WATER DISTRIBUTION SYSTEM to serve CHICK-FIL-A 7320 WEST TAFT STREET CITY OF WICHITA, KANSAS

Gary Janzen, P.E. City Engineer
Project Number
2071 PPW (183021)

AS BUILTS

SHEET
 PPW
 PLAN & PROFILE

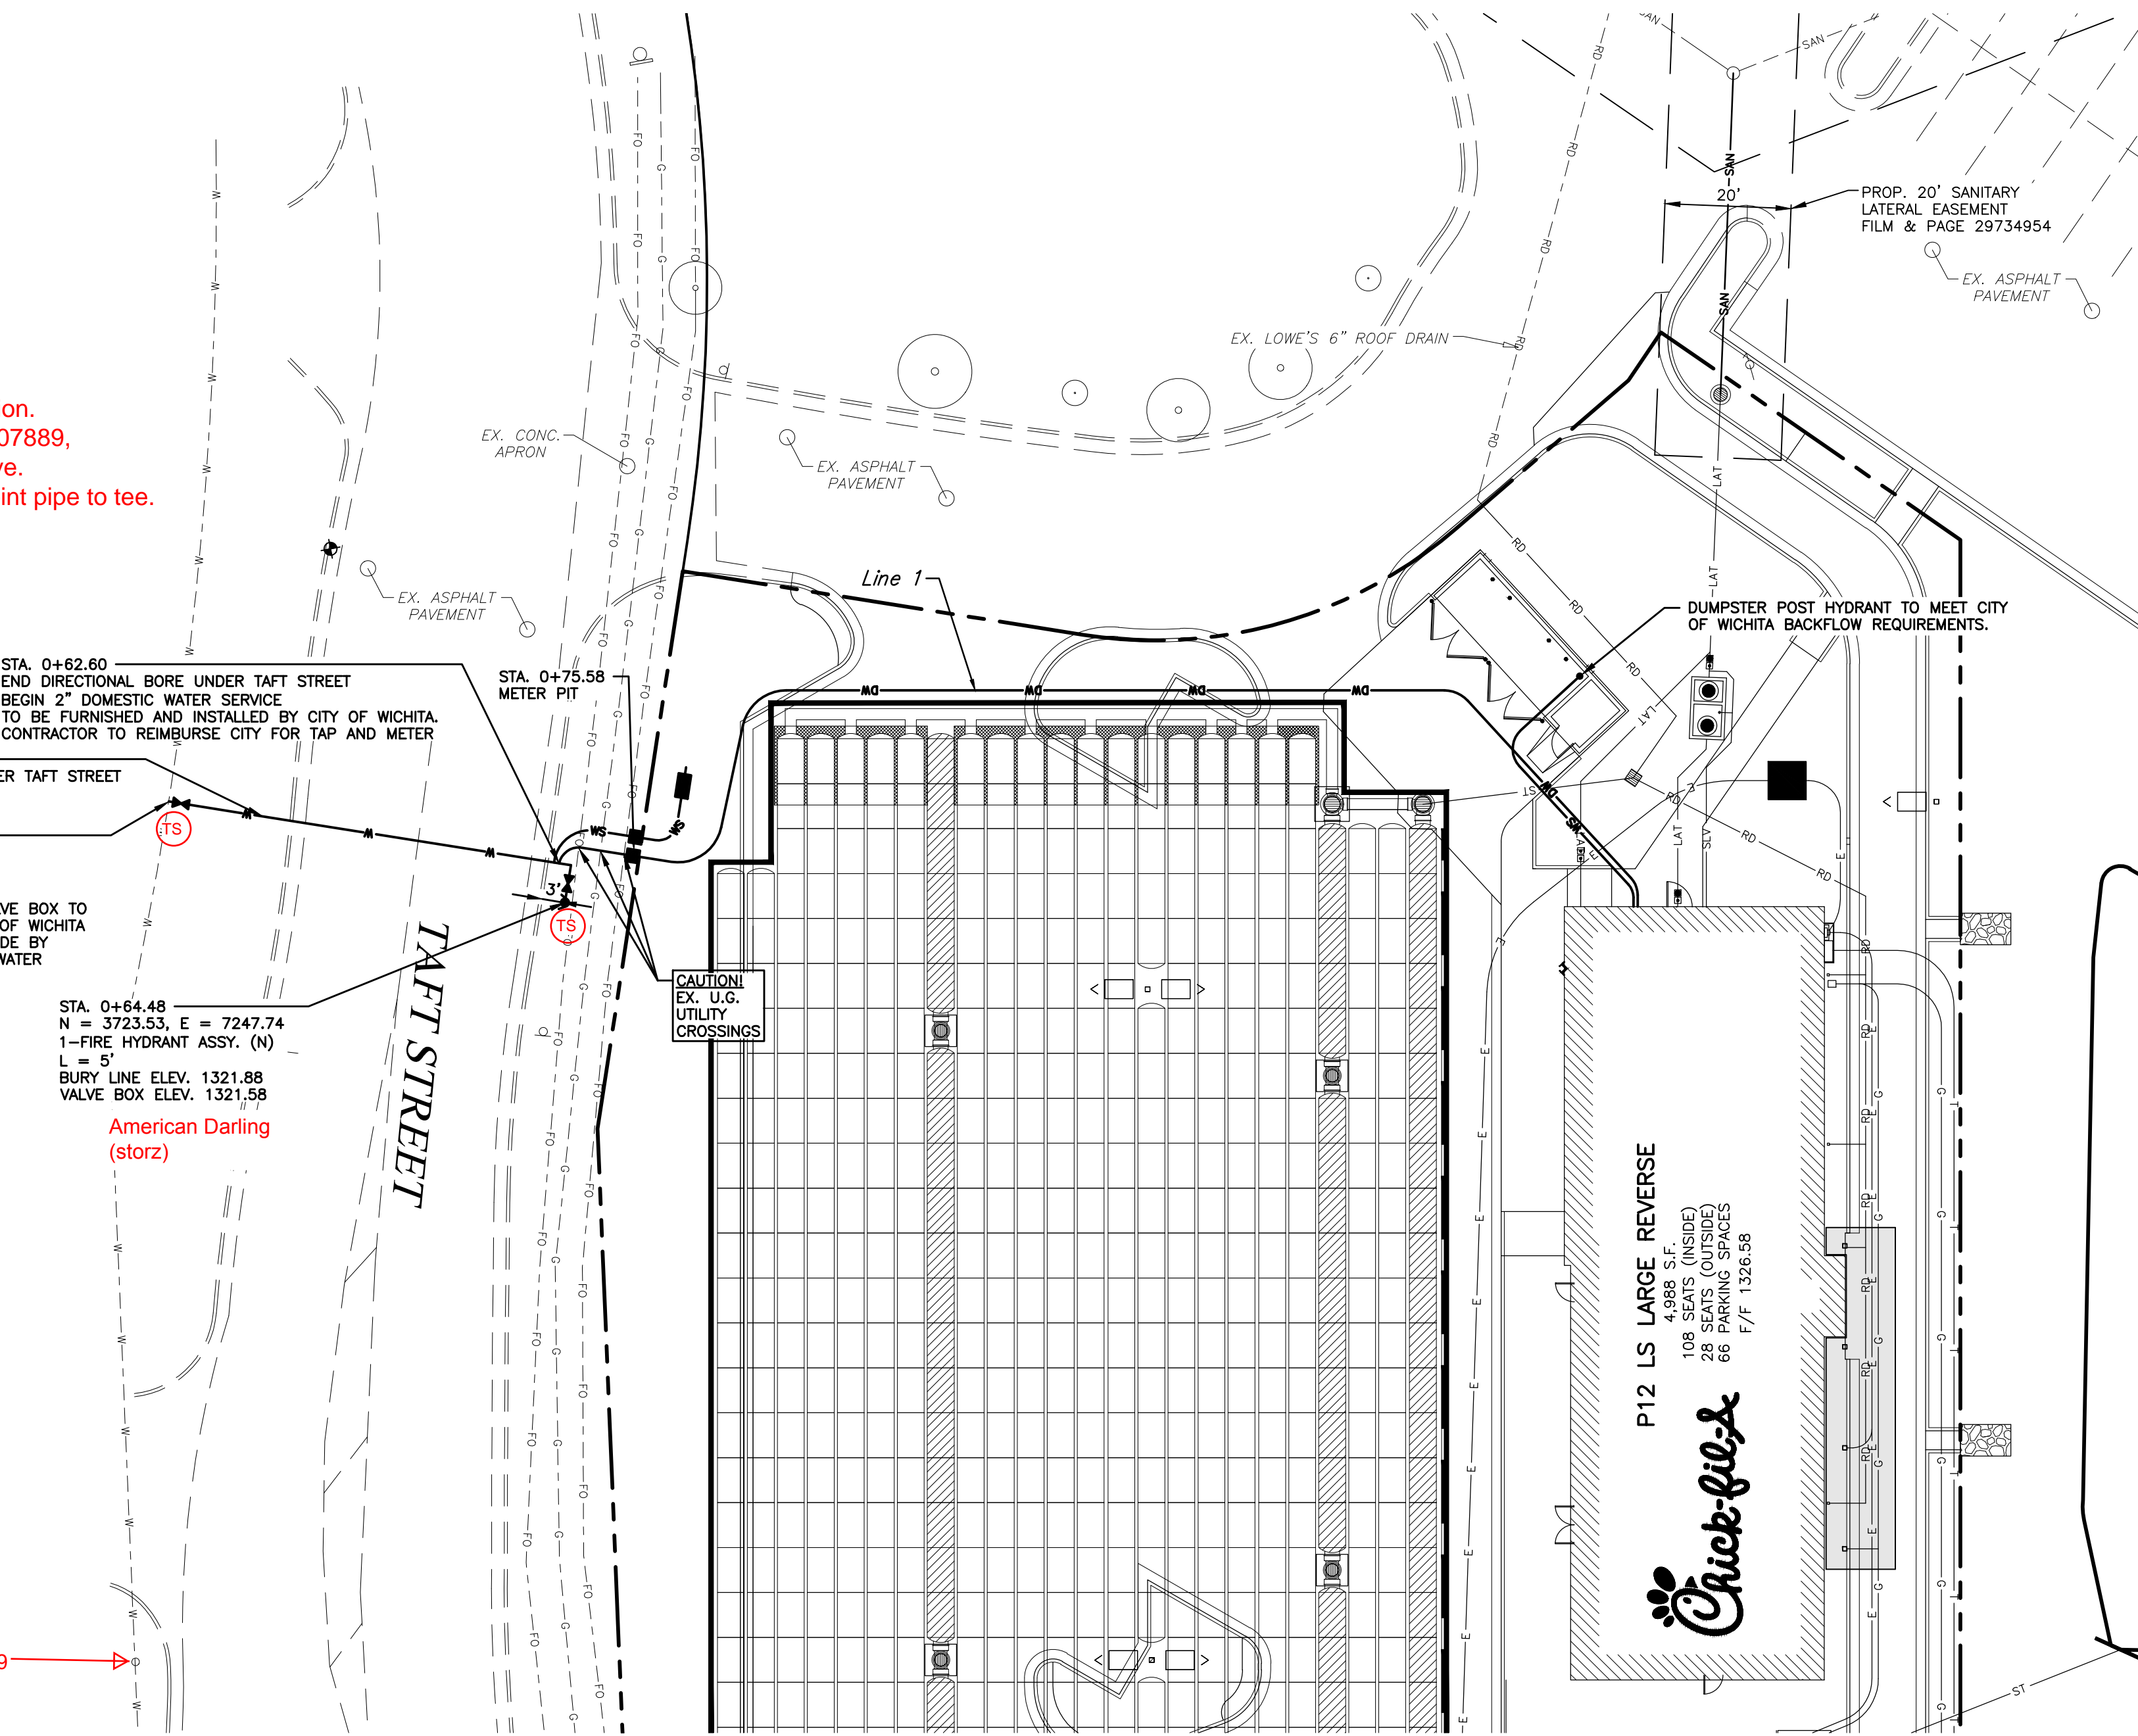
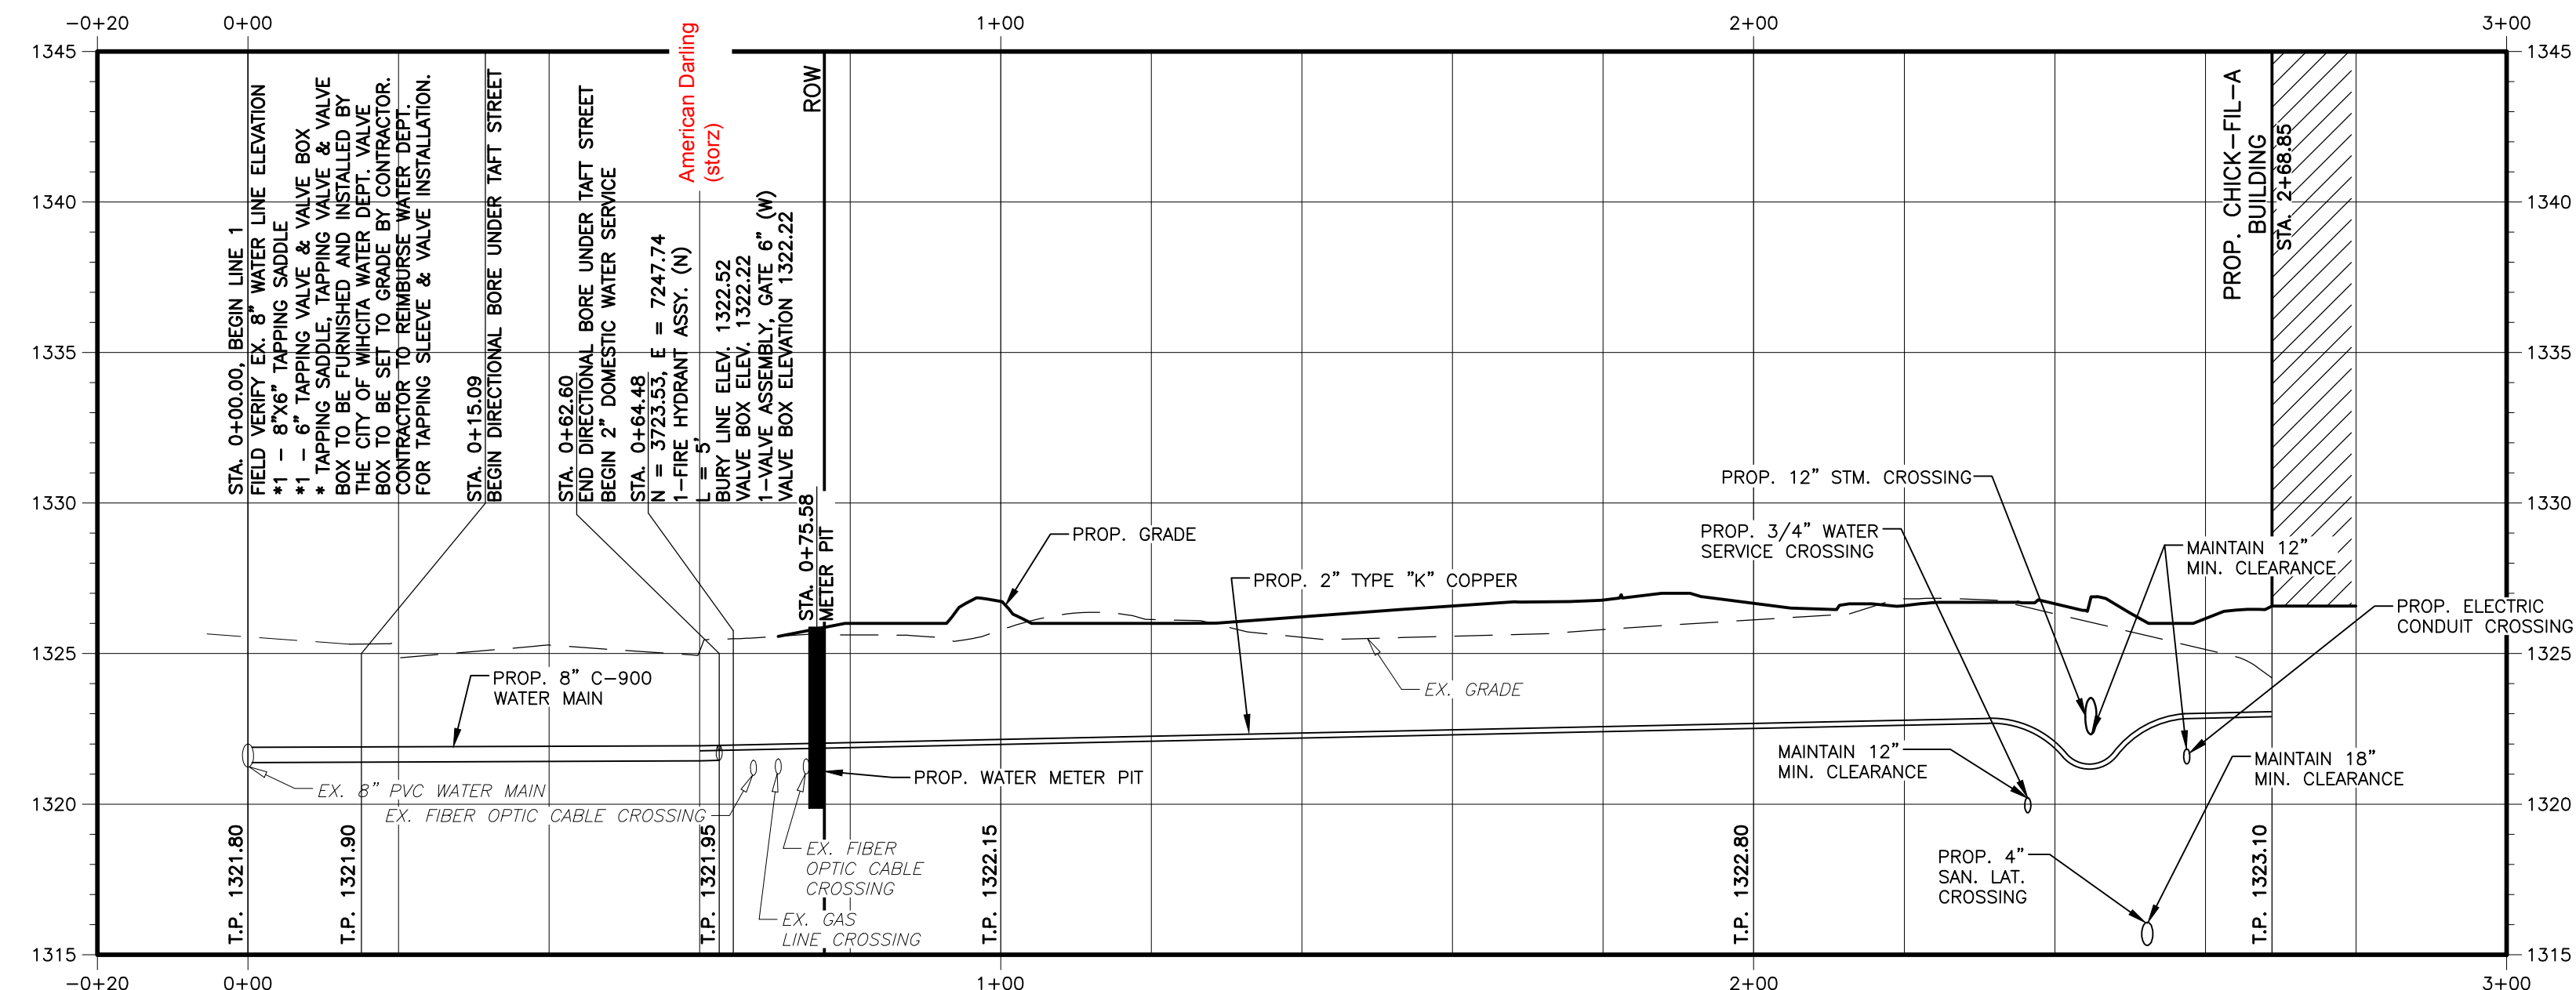
Conflict with gas and fiber optic lines - moved tee
 North and fire hydrant

Eisenhower Airport Parkway & Taft Intersection.
 South side of Taft and west to existing FH # 07889,
 then west along curb line 133' to tapping valve.
 From tapping valve north, 57' of restrained joint pipe to tee.
 From tee 6' east to fire hydrant.

Fire hyd. Assy. tee is 57' North of tapping valve

Greg approved
